ACCESSION NBR: 8710260347      DOC. DATE: 87/10/20      NOTARIZED: NO      DOCKET #  
 FACIL: 50-335 St. Lucie Plant, Unit 1, Florida Power & Light Co.      05000335  
 AUTH. NAME      AUTHOR AFFILIATION  
 WOODY, C. O.      Florida Power & Light Co.  
 RECIP. NAME      RECIPIENT AFFILIATION  
                                  Document Control Branch (Document Control Desk)

SUBJECT: Forwards response to 870820 request for addl info re 870612 application for amend to License DPR-67, authorizing replacement of spent fuel pool racks. W/nine proprietary oversize drawings. Encls withheld.

Re: St. Lucie Unit I  
Docket No. 50-335  
Spent Fuel Pool Rerack - Design and Analysis

RESPONSES TO NRC LETTER

FIGURE JPE-LR-87-043-5

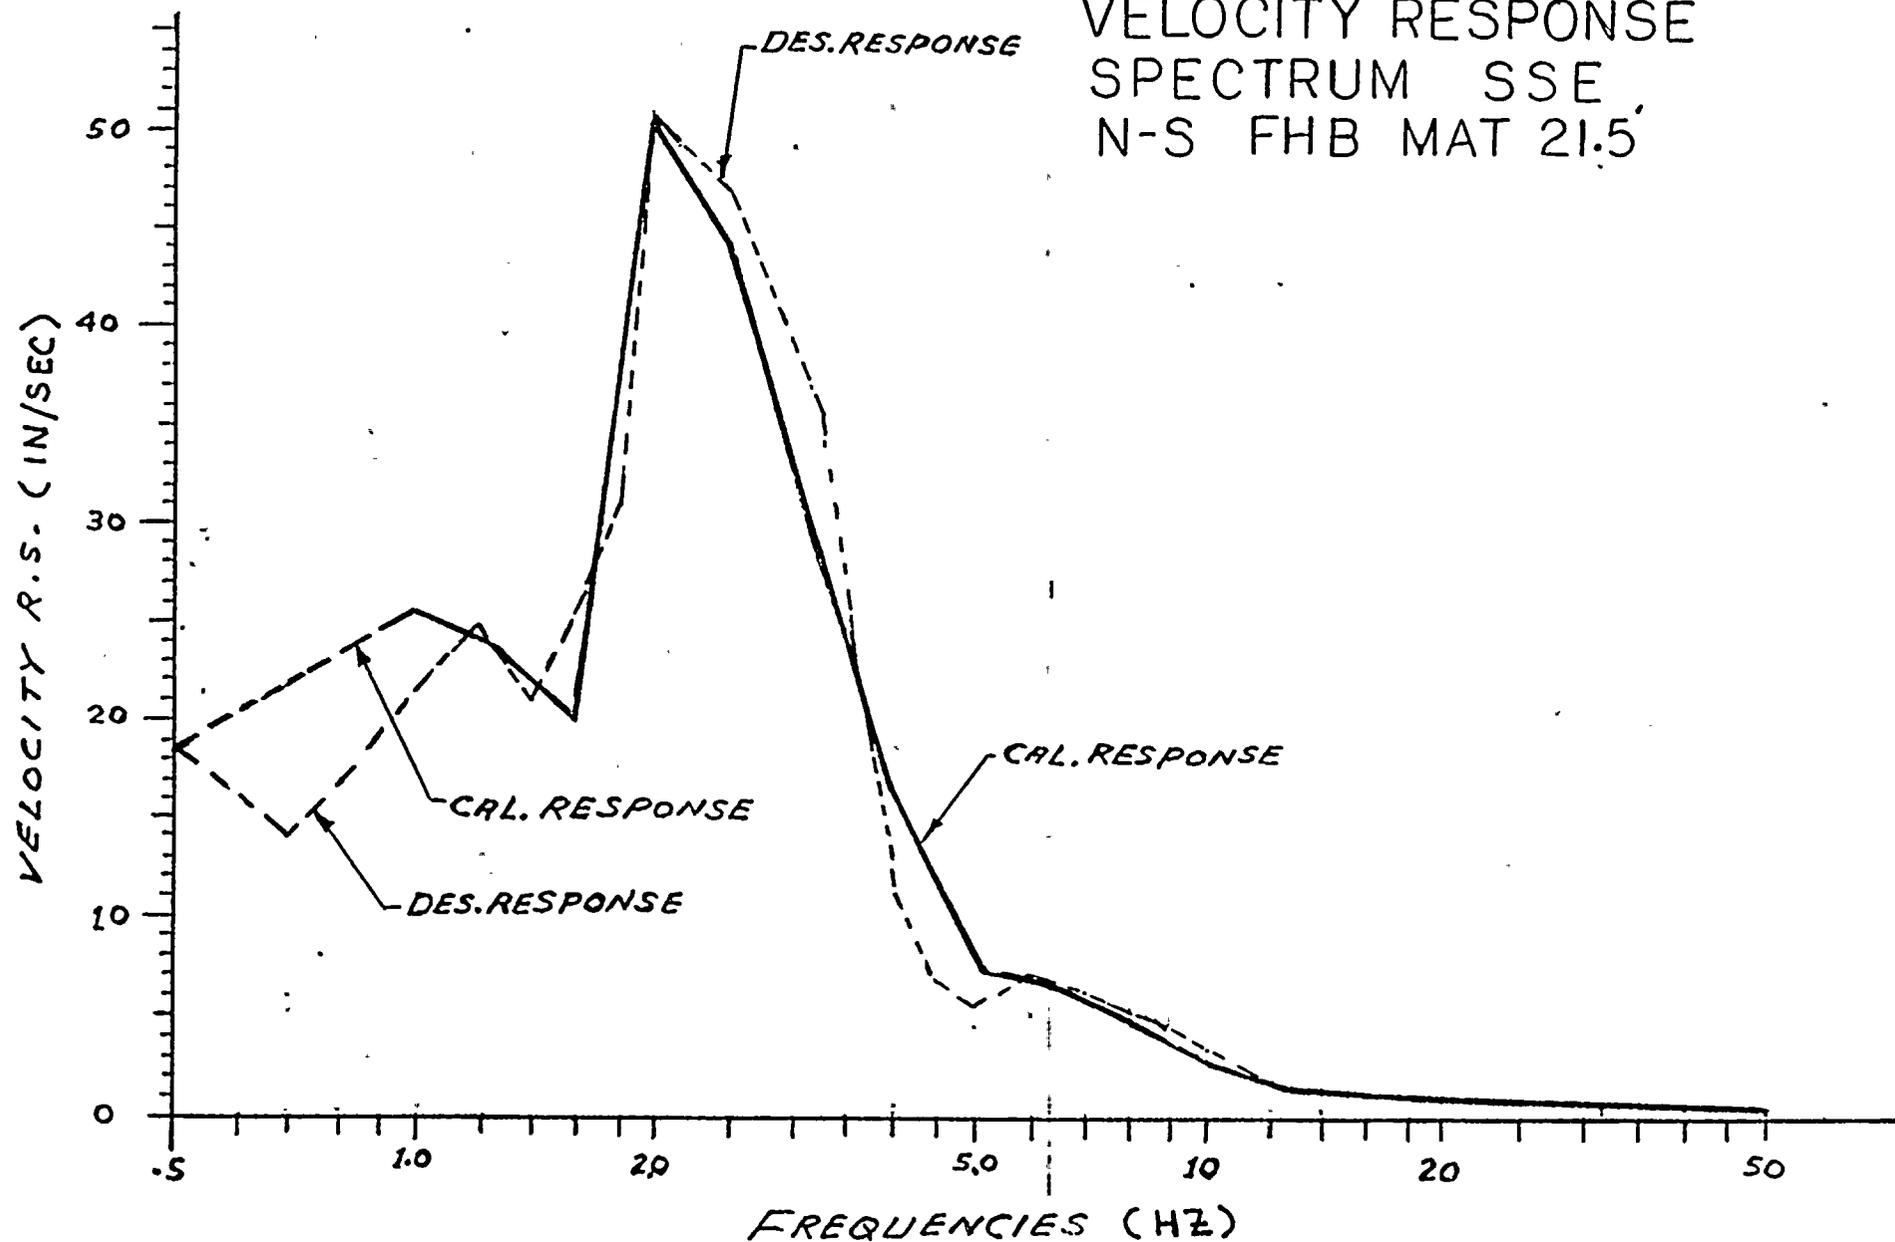
Question 2c - Provide a comparison of the response spectra for the pool floor motion shown in Figures 4-12, 13, 14, with the corresponding design response spectra of Figure 4-9.

Response 2c - The attached Figures JPE-LR-87-43-4, 5 and 6 provide a comparison of the design response spectra with the calculated response spectra corresponding to the artificially generated time histories. For clarity, velocity response spectra rather than acceleration response spectra are presented, as velocity spectra will accentuate the differences in the lower frequency range.

The plots demonstrate that the calculated curves closely envelope the design curves.
